From: [REDACTED]
To: [REDACTED]
Sent: 2/24/2021 8:52:18 AM
Subject: RE: O8W-PM 35217268, 35224712, 35224713 - Bucks Creek 1101 Phase 1,2&3 - Pre-Engineering Meeting

Subject: O8W-PM 35217268, 35224712, 35224713 - Bucks Creek 1101 Phase 1,2&3 - Pre-Engineering Meeting

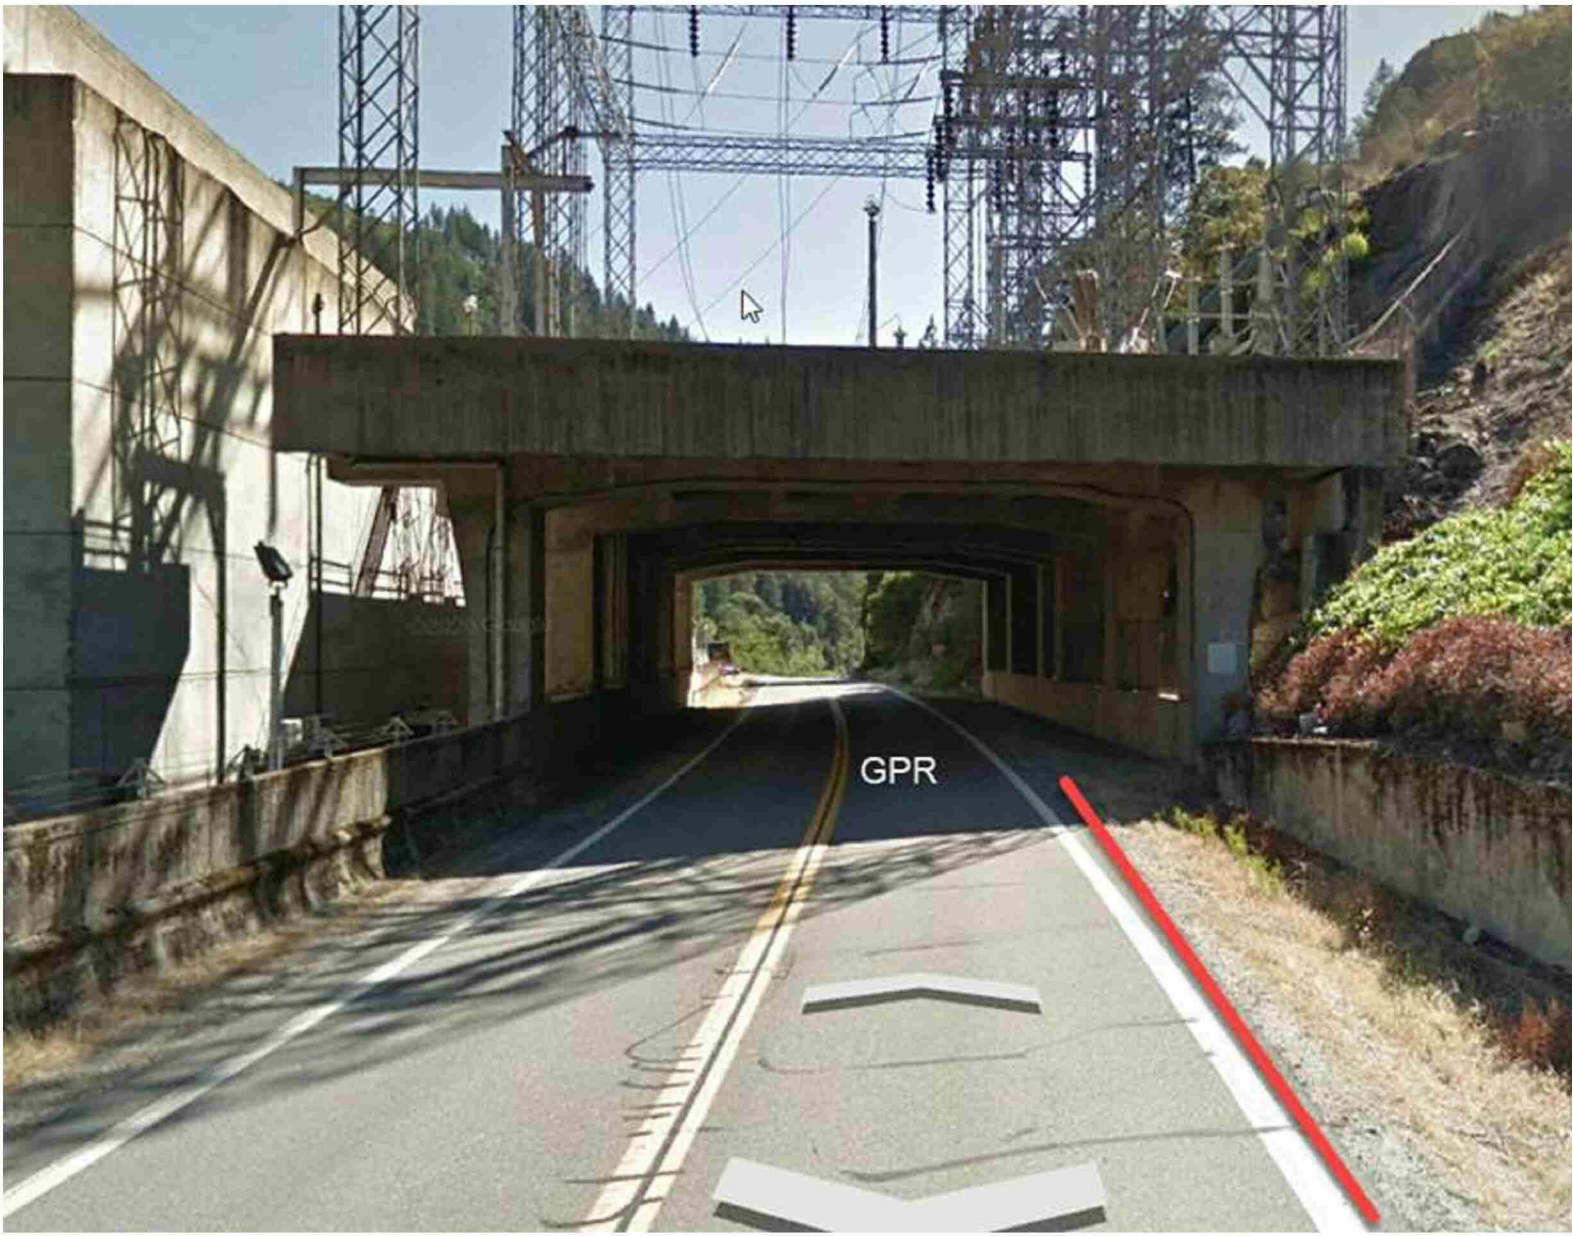
Your outlet red-line Bucks Creek looks close to what I was thinking. Need to work with [REDACTED] to get this designed with a single 6" and use #5 boxes with 200A cable. There is not a reason this will need (2) 6" and 1-4" and 7 boxes. There is probably only 20a peak on the primary now.
